To: T10 Technical Committee
 From: Rob Elliott, HP (elliott@hp.com)
 Date: 20 May 2002
 Subject: T10/02-198r0 SAS OOB timing

Overview

The OOB timing requirements need to be more precise, listing the transmit burst time and specifying receiver tolerances.

Figure 1. Phy reset sequence OOB signal generation-transmission and detection

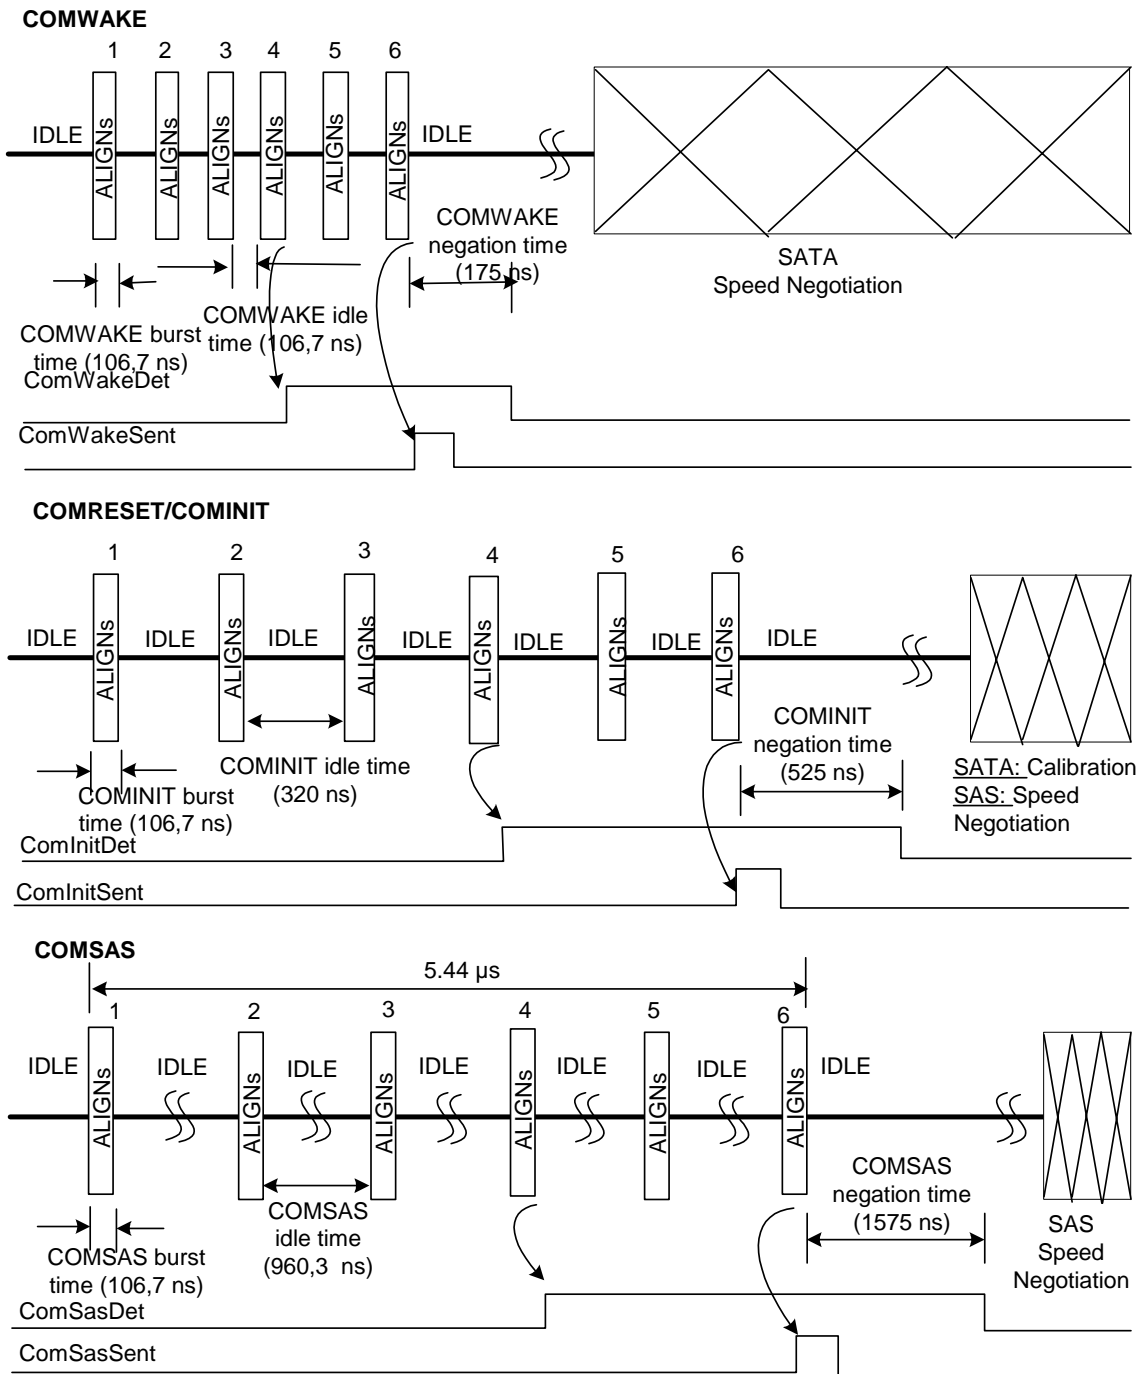
[Editor's note: change all figures to use the acronyms rather than absolute times]

Figure 1 illustrates the timing required for the generation and detection of all the SAS OOB signals. The signals labeled ComXxxDet and ComXxxSent (where Xxx is Wake, Init, or Sas), are inputs to the SAS phy Initialization-layer state machine. ComXxxDet is an output from the OOB detection circuitry that indicates the detection of an incoming COMINIT, COMWAKE, or COMSAS sequences signal. ComXxxSent is an output from the OOB generation circuitry that indicates that a burst of six COMWAKE, COMINIT, or COMSAS sequences signals has been output onto the link.
